# Tivoli MFG Ltd.

## Service Bulletin

Bulletin No: SOSR001

Purpose: Reservoir installation for Spin Out Base Gearboxes

OPLOSSING  
 SOLUTION

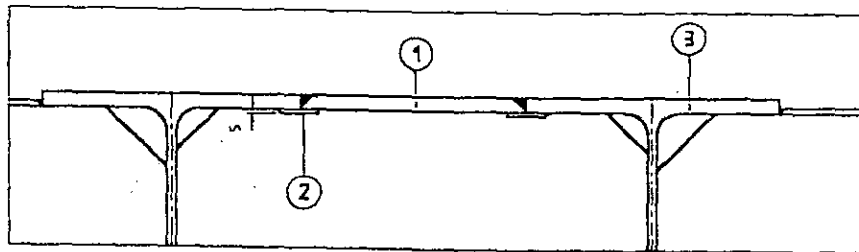
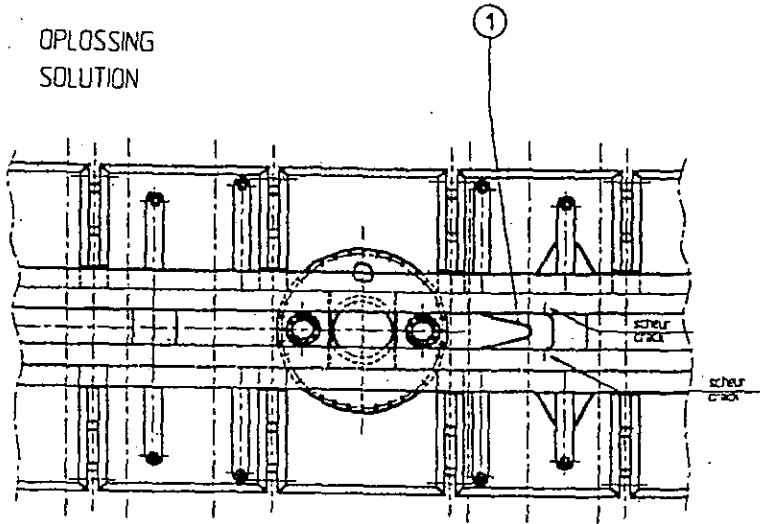
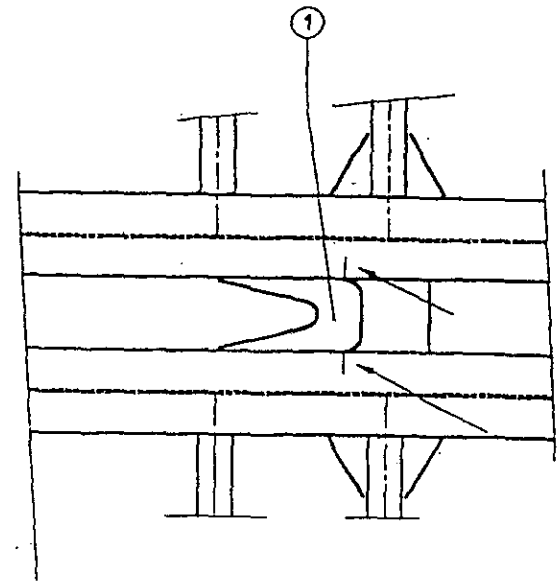
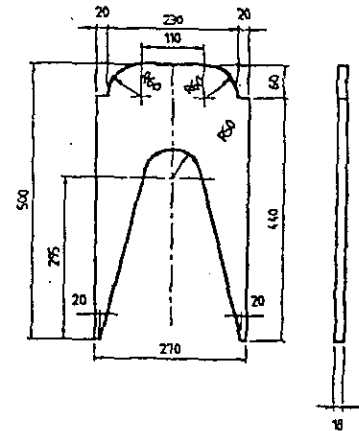
It has come to the attention of **Tivoli Mfg. Ltd.** from the original designers of the Spin Out, **KMG Europe BV**, that there has been cases where cracks have been detected on the center I beam of the rotating base frame as described in the accompanying drawings.

If cracks are detected as described in the attached drawings complete repair procedures as described below by repairing crack and installing gusset plate.

1. Locate end of crack and drill a 1/4" hole through beam where crack ends.
2. Grind and clean out crack to about 1/8" of bottom of beam.
3. Weld up ground out crack and grind of weld flush with I beam.
4. Install gusset plate as described in attached drawings and weld in place.

- 1 LAS STRIP POS. 2 ONDER DE CHASSIS BALKEN POS. 3  
 WELD PLATE POS. 2 UNDER THE CHASSIS BEAMS POS. 3
- 2 LAS PLAAT POS 1 IN DE TRAILER  
 WELD PLATE POS. 1 IN THE TRAILER
- 3 REPAREER DE SCHEUR. DOOR DE SCHEUR UIT TE SLIJPEN EN DICT TE LASSEN  
 REPAIR THE CRACK . BY GRINDING OUT THE CRACK AND WELD THE HOLE.

Fig. 1

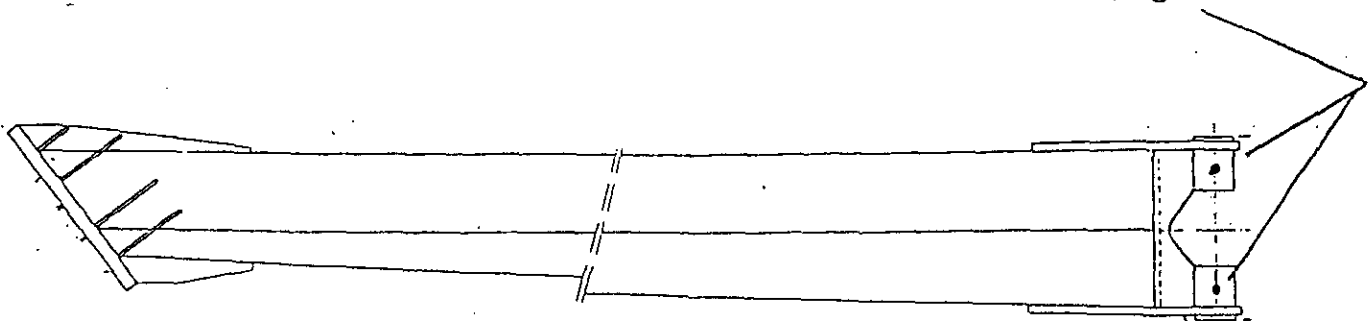
1. With both pins installed in sweep, Remove the threaded collar from the bottom of the pin below the sweep hub. This requires the removal of a set screw locking the collar to the threads.
2. With the other pin slightly loosend, remove hing pin by tapping out with hammer and brass or alluminum rod.
3. After pin is removed drill a 3/16" hole through the center of the sweep bushing collar so the hole comes through between the two internal bushings.
4. After all 3/16" holes are drilled 2 per sweep, 8 total, counter bore a 21/64 hole approximately 10mm deep ( 3/8" ). As in step 1 use a shop vac to collect filings while drilling.
5. Tap counter bore with a 1/8" pipe tap, Clean toughly.

Locate Grease Fittings

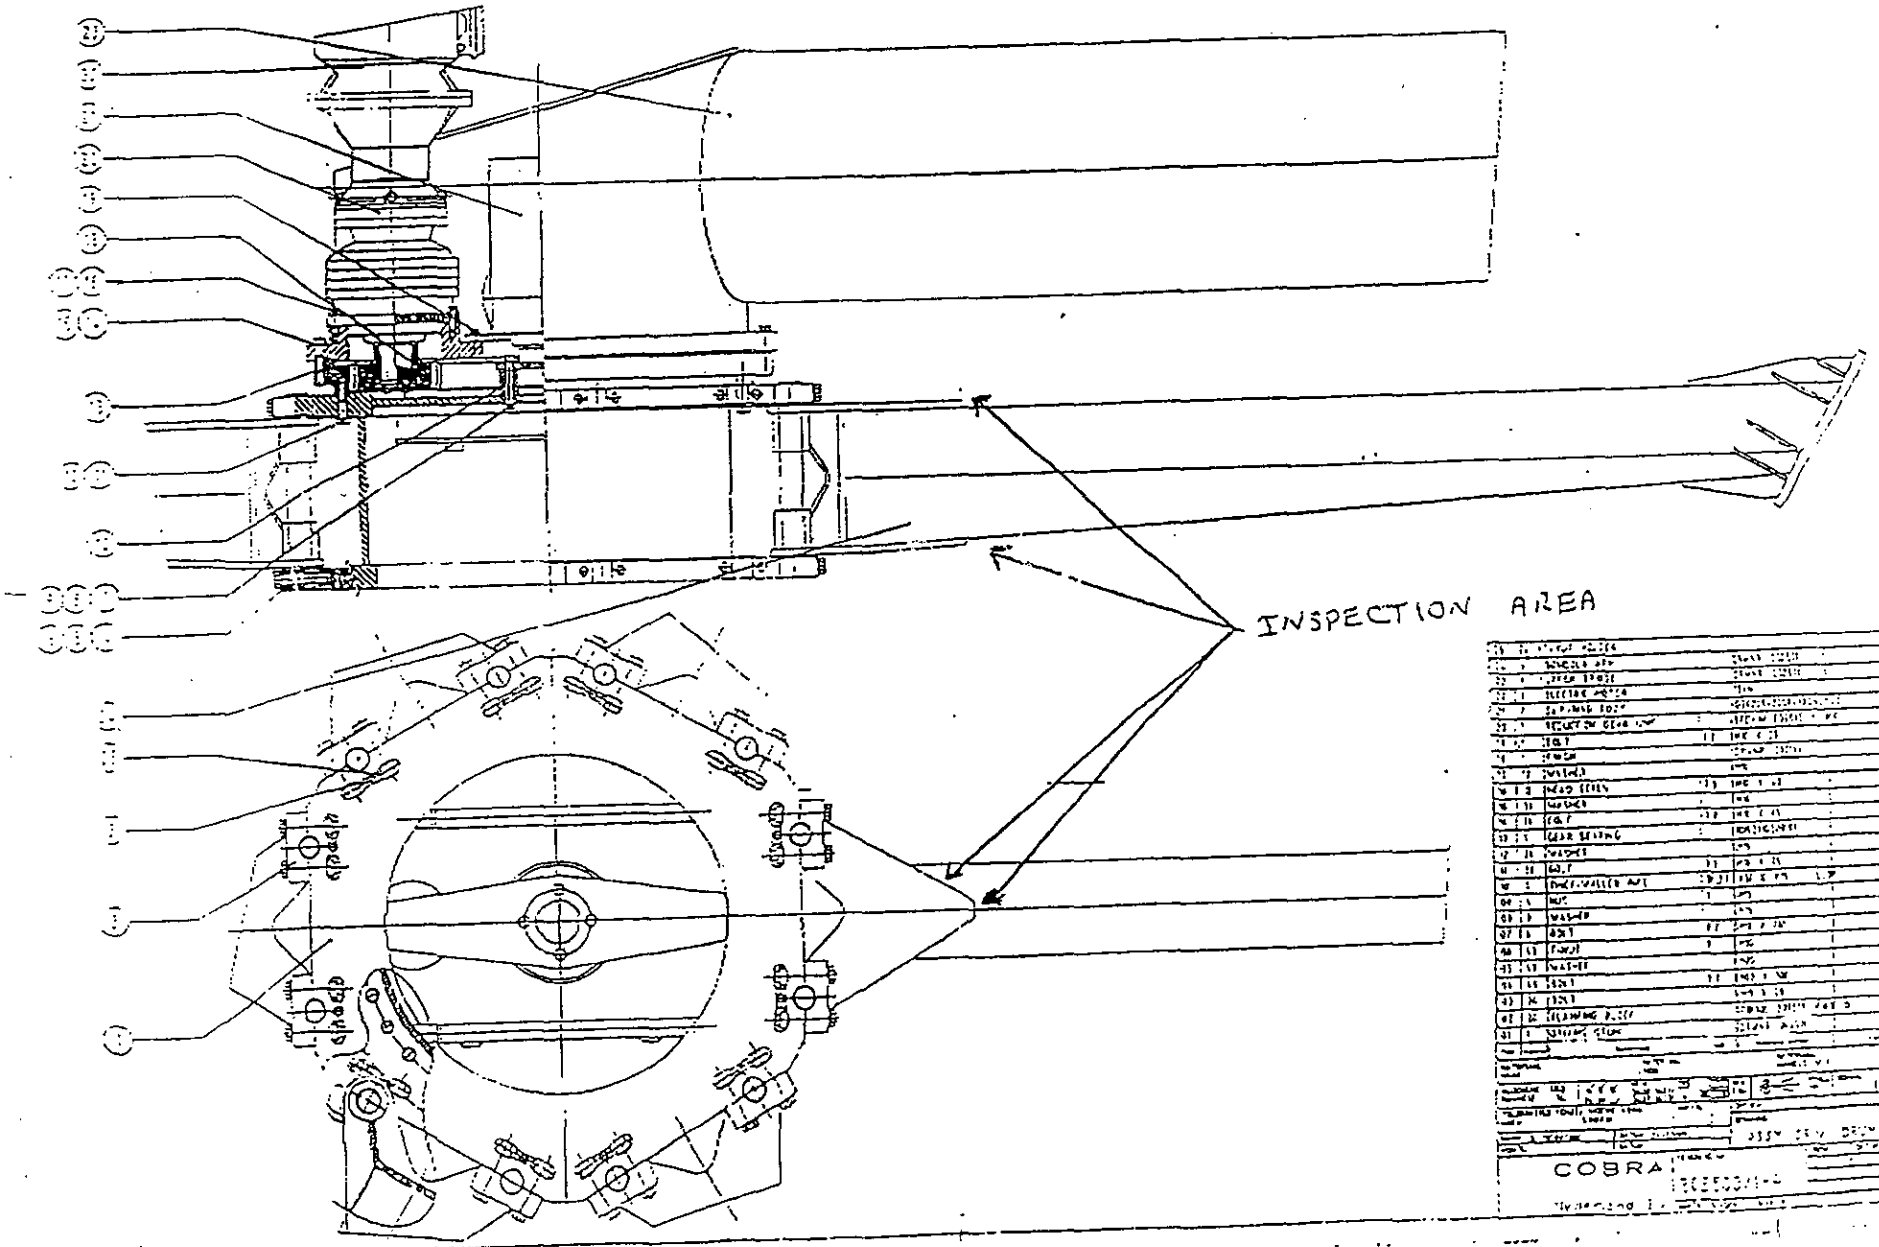
Tivoli Mfg. Ltd requires that all operators inspect the areas indicated on the attached drawings. If cracking is detected please report to AmTech / Amusement tech. intl. Inc. at 817-641-5045 for repair procedures and gusset kits.

If no cracks are detected as described in the attached drawing, a monthly inspection of this area of the sweeps should added to your existing inspection procedures.

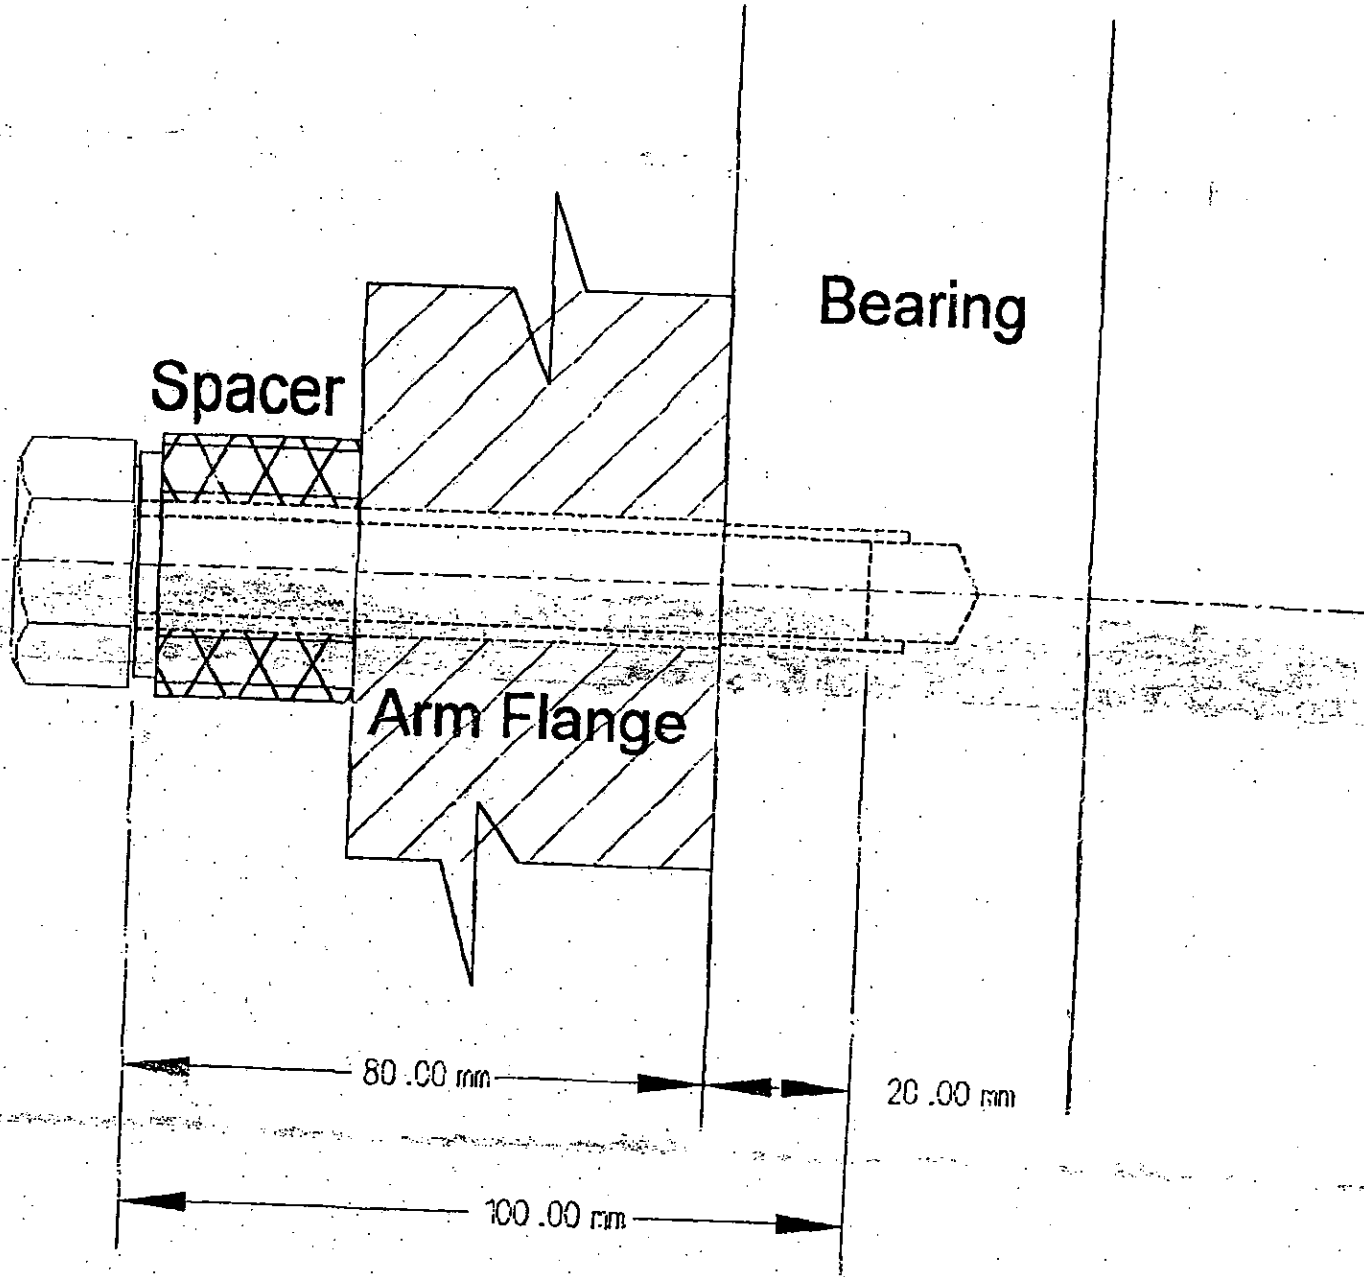
It has come to the attention of Tivoli Mfg. Ltd. of an instance where two of the arm to bearing attachment bolts had broken. Though this has happened on only one ride, Tivoli Mfg. Ltd in the interest of safety has decided to provide a bolt upgrade kit to be installed on all 36-bolt arm bearings.

These bolts and spacers, along with the hardened flat washers removed from the bolt removed must be installed as shown on the accompanying drawing.

Replace all bolts one at a time in a star pattern around the bearing until all 30 bolts have been replaced.

Torque all bolts to 210 ft Lbs.

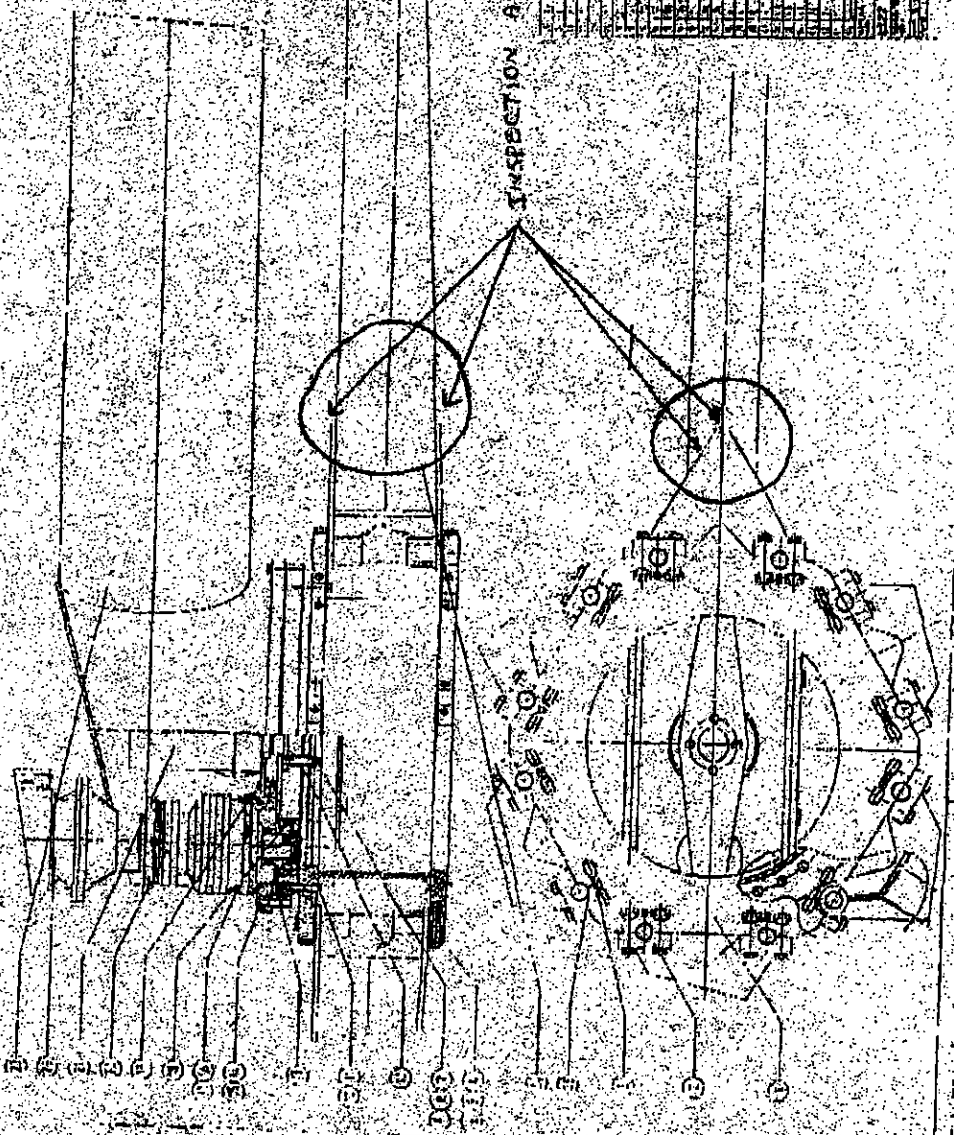
As a result of the incident on January 3, 2003 where a vehicle sweep of a Spin Out broke away from the hinge/attachment plates, Tivoli Mfg. Ltd. is issuing this revised inspection procedure concerning the area of the sweeps described on the attached drawing 202503/1-A.

Inspect area around both top and bottom hinge / attachment plates on all six sweeps located where sweeps are attached to the center hub (see drawing 202503/1-A attached)

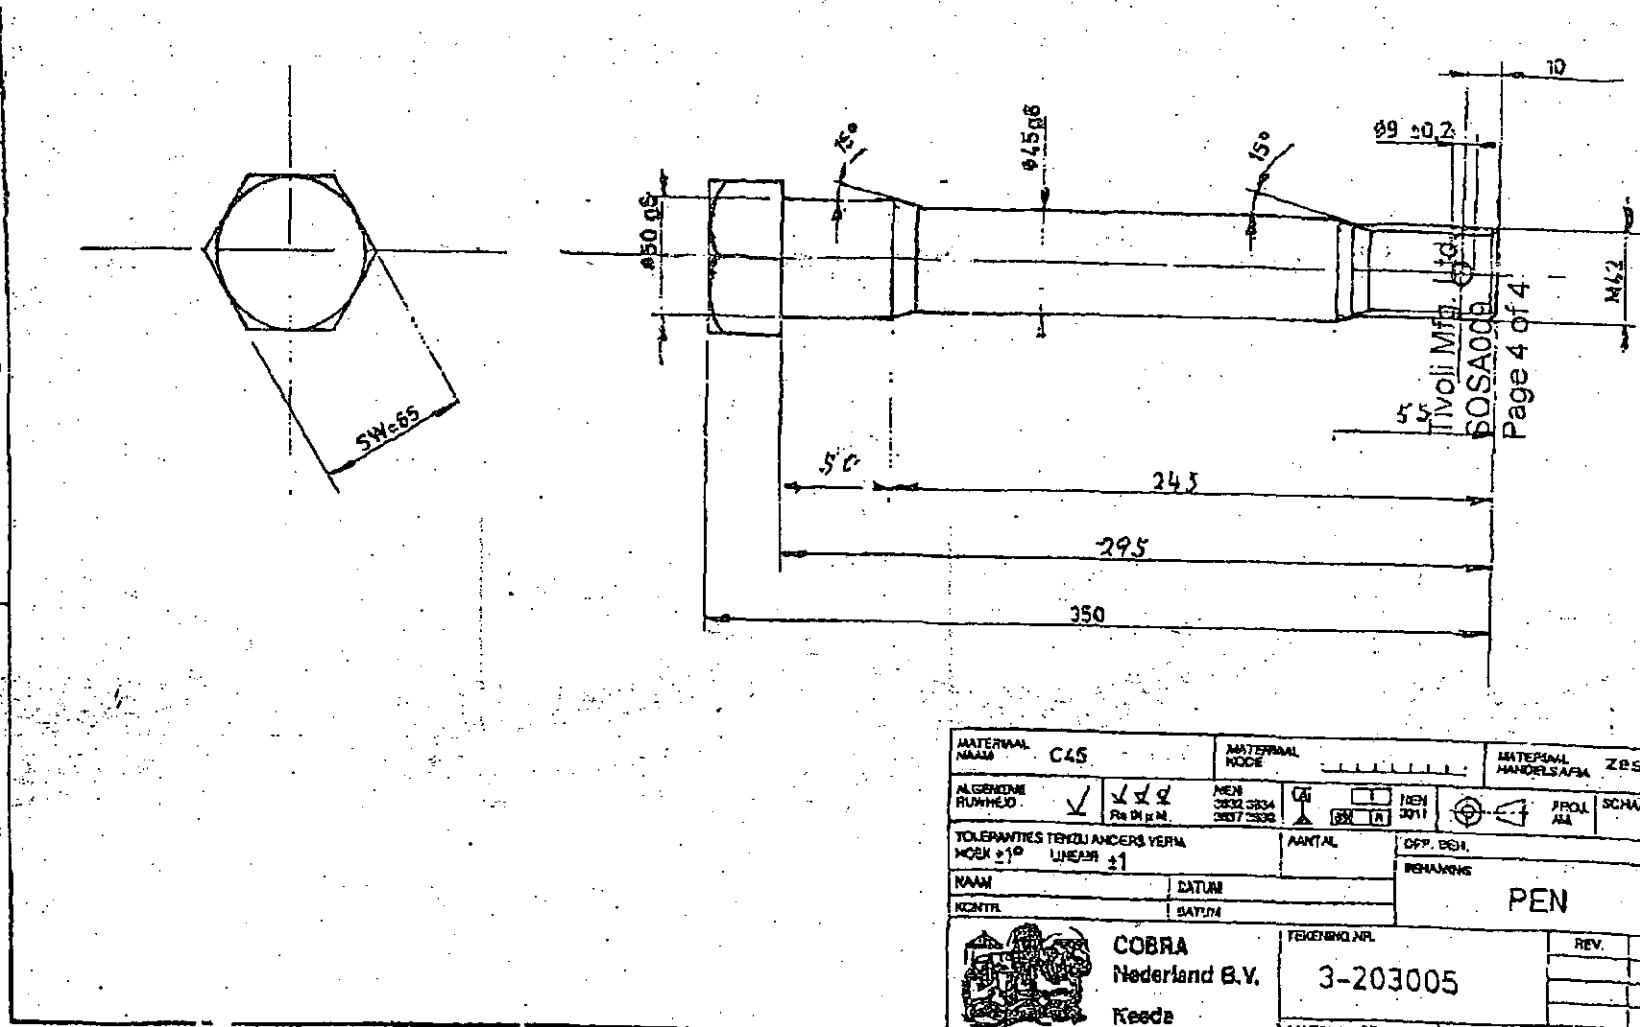
**Removable sweep pins.** Only pins installed and removed each time ride is set up [four (4) pins]. See drawing HATC-W003 Attached.

**Vehicle attachment Pins.** (If ride is equipped) Two pins per Vehicle (See drawing 3-203005 attached). **Note:** Earlier rides were manufactured with 10 bolt flange vehicle connections and are not included in this inspection.

Figure 1

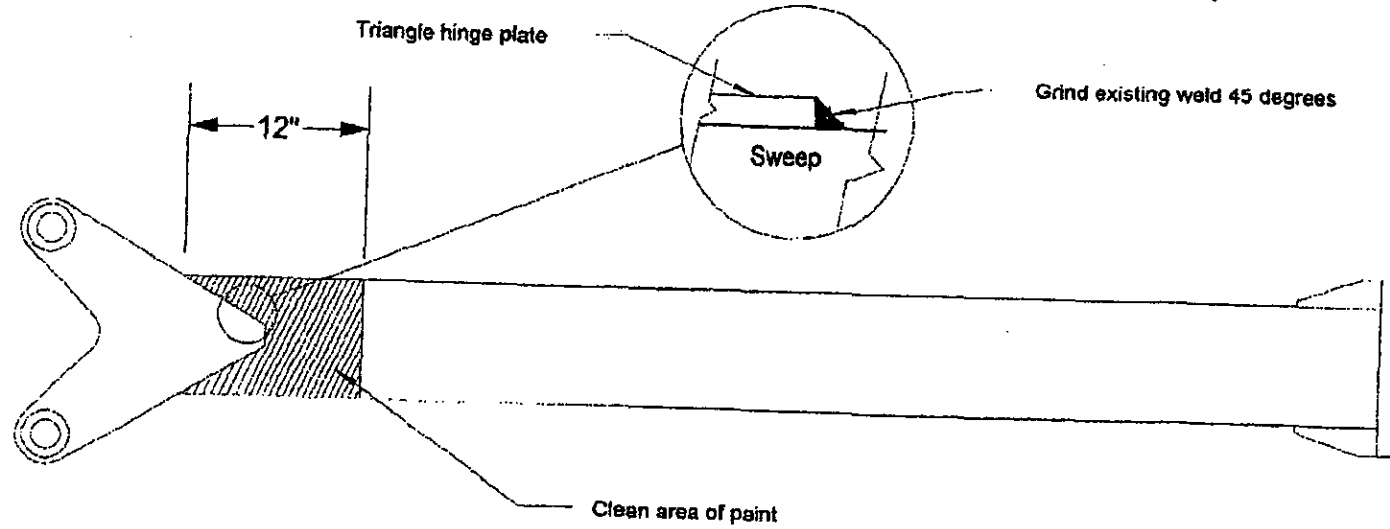
- Step 1: Raise leveling jacks so rotating platform is as close to level as possible without interfering with fixed platform
- Step 2: Remove Vehicles from Sweep and move to edge of platform. Make sure vehicles are secure and will not roll on platform.
- Step 3: Remove sweep light fixtures. Be aware of small spacers on mounting bolts.
- Step 4: Clean off paint and around where edge of gusset plate will be welded to sweep (see fig. 1, drawing SOSA010C).

- Step 5: Grind weld around triangle hinge plate (See figure 1 Drawing SOSA010C) so weld is about 45°.
- Step 6: lay Gusset plate approximately 1/8 inch from base of weld on Triangular hinge plate. (See figure 2 drawing SOSA010C)

Figure 2

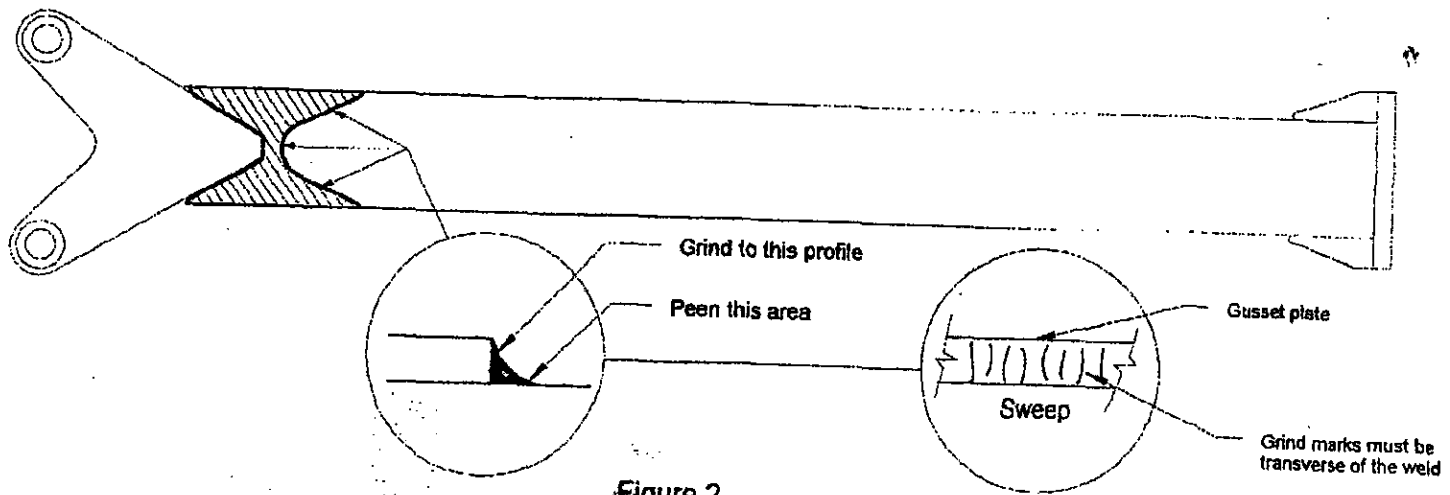
- Step 10: Grind weld on vehicle side of gusset as described in figure 2 drawing SOSA010C. Grinding must be transverse of the weld axis.
- Step 11: Peen weld with blunt instrument at the toe of the weld on top flat part of sweep as described in figure 2 drawing SOSA010C.
